**CITY OF SULLIVAN, MISSOURI
AND
SULLIVAN REGIONAL AIRPORT
ADDENDUM NO. 1**

MoDOT PROJECT NO. 25-112B-2

**BASE BID: REPLACE RUNWAY 6-24 EDGE LIGHTING AND VAULT
ALTERNATE NO. 1: REPLACE PRIMARY WIND CONE
ALTERNATE NO. 2: REPLACE RUNWAY 6-24 PAPI
ALTERNATE NO. 3: REPLACE BEACON ON EXISTING POLE
ALTERNATE NO. 4: INSTALL RUNWAY 6-24 REILS**

ADDENDUM NO. 1

Sheet 17 of 30, PROPOSED ELECTRICAL PLAN 3

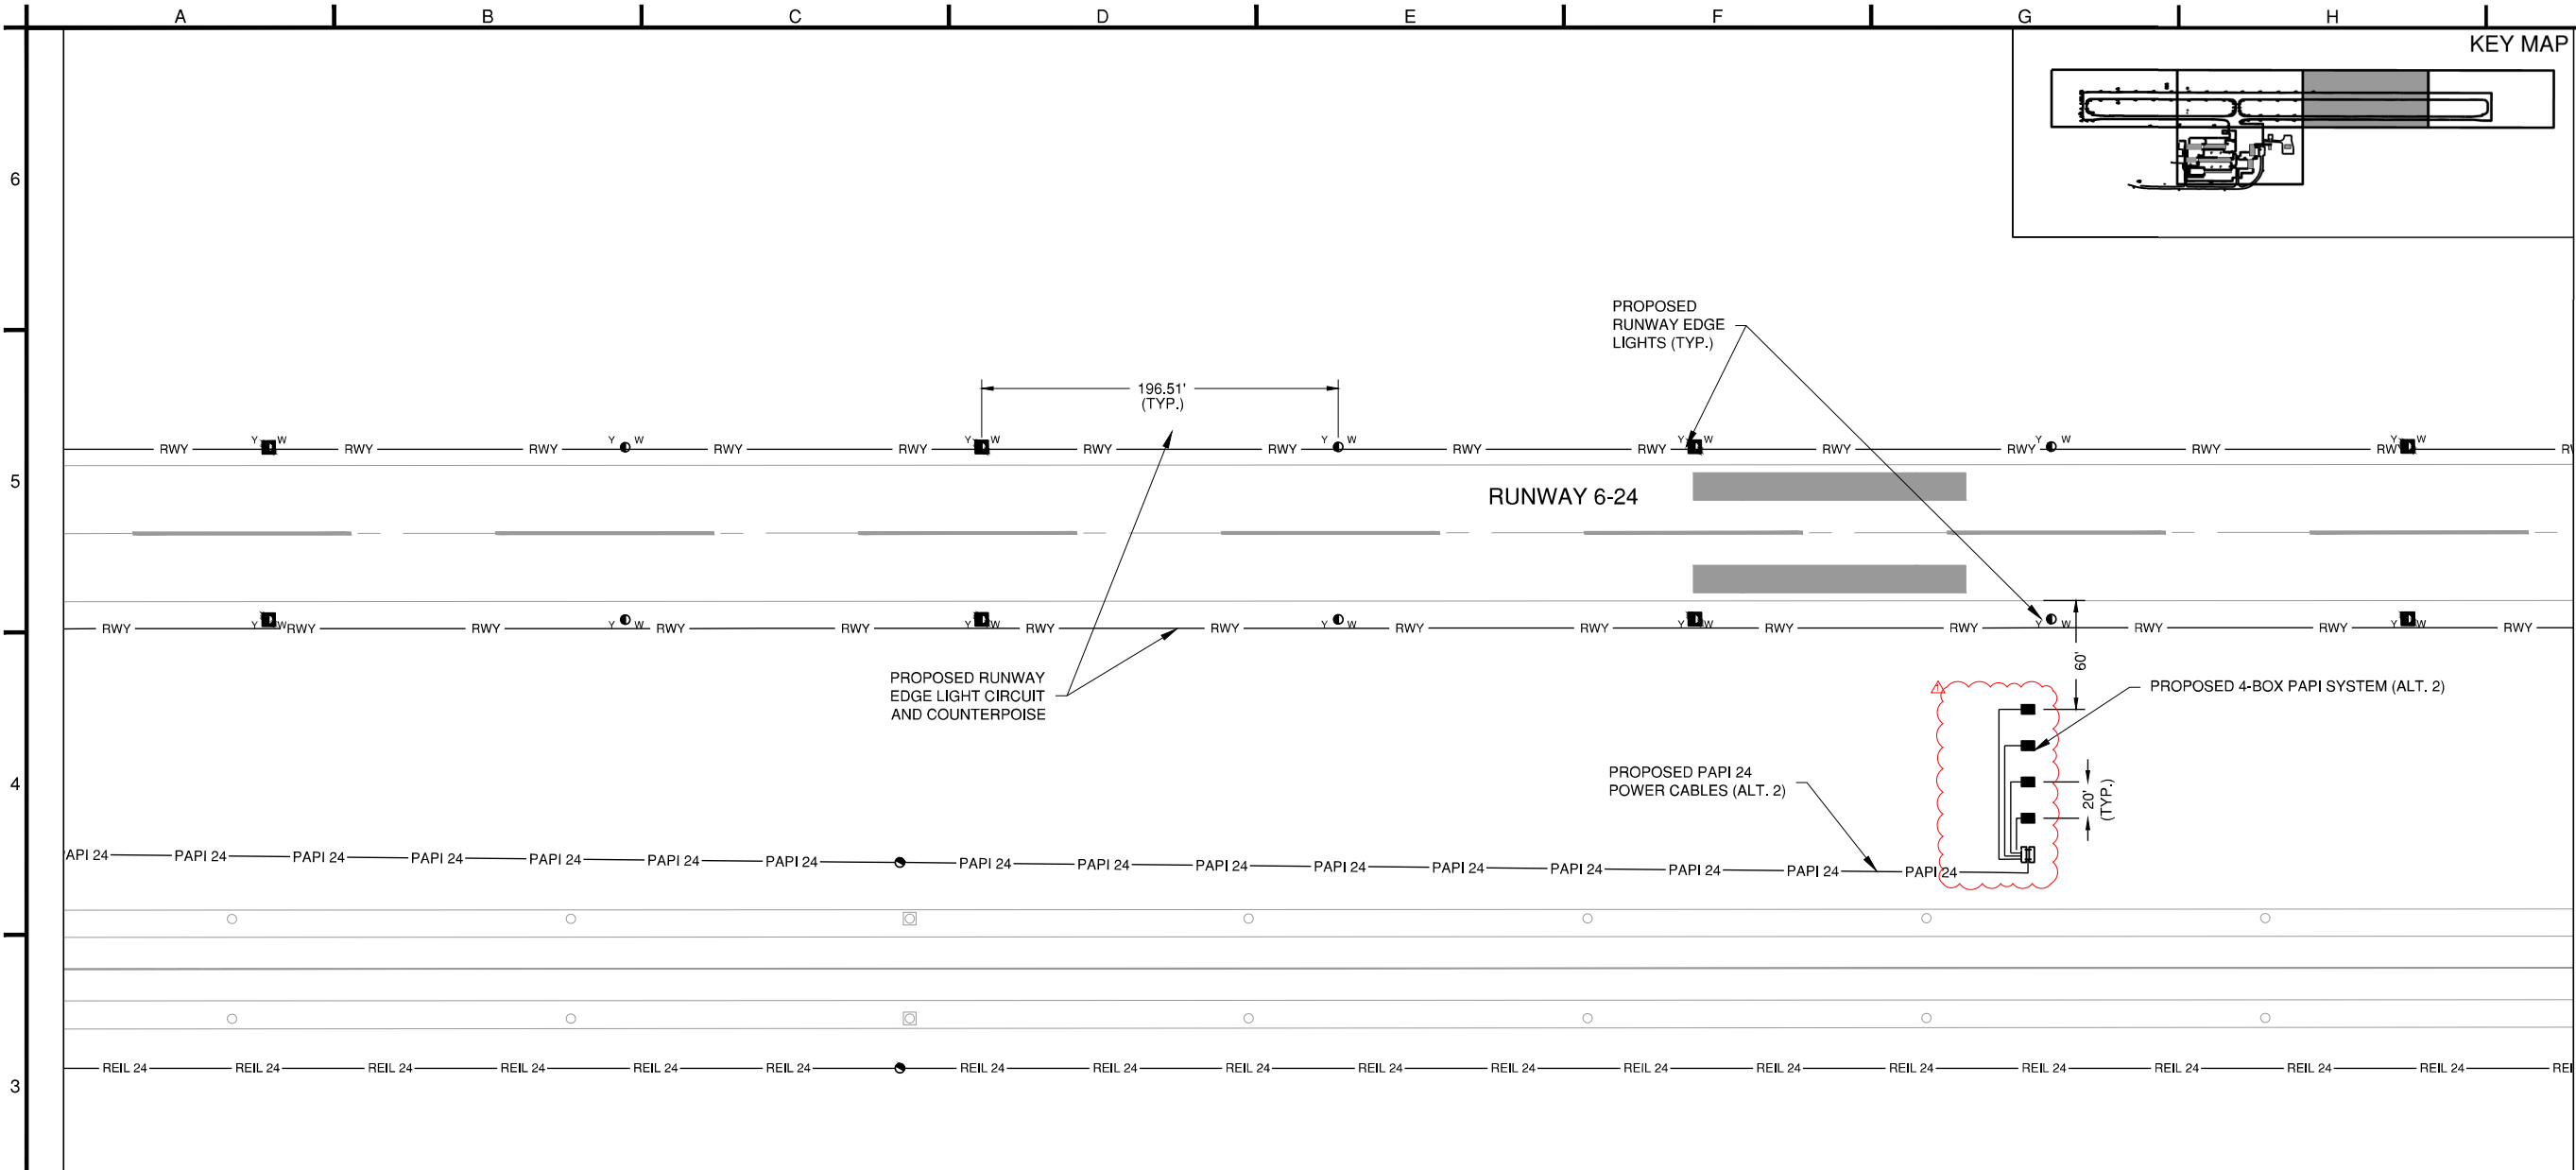
CLARIFICATION: Location of 24 PAPI revised to set LHA beams one foot above new runway reference point, due to grade conflicts at the outer LHA box because of rising ground.

Sheet 23 of 30, ELECTRICAL DETAILS 4

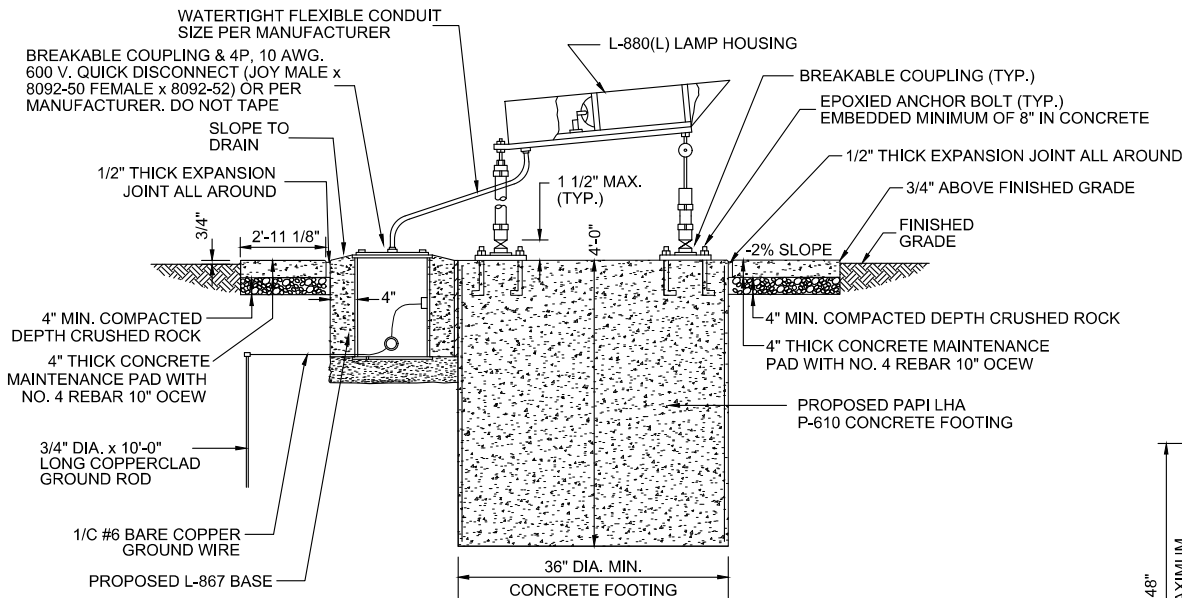
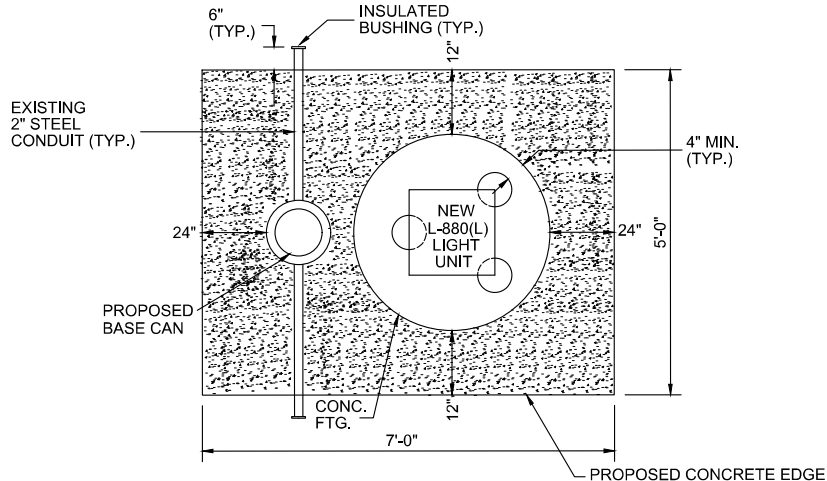
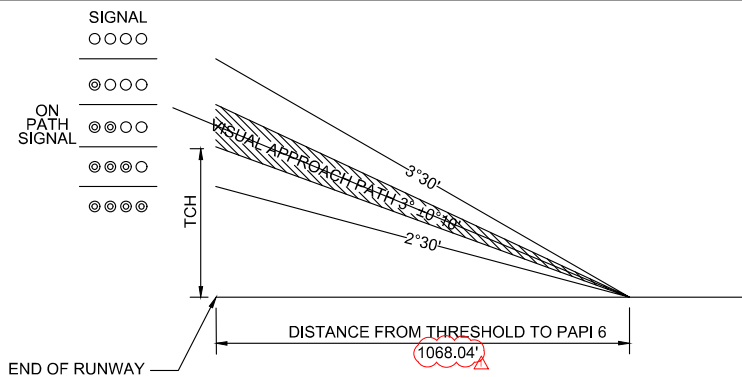
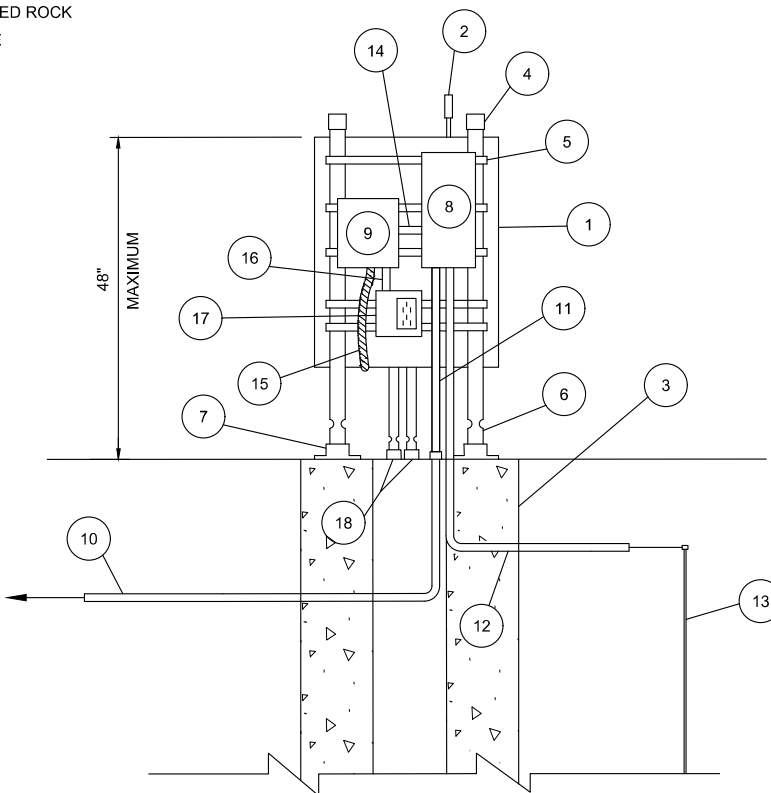
CLARIFICATION: Location of 24 PAPI revised to set LHA beams one foot above new runway reference point, due to grade conflicts at the outer LHA box because of rising ground. 6 PAPI distance from threshold also revised.
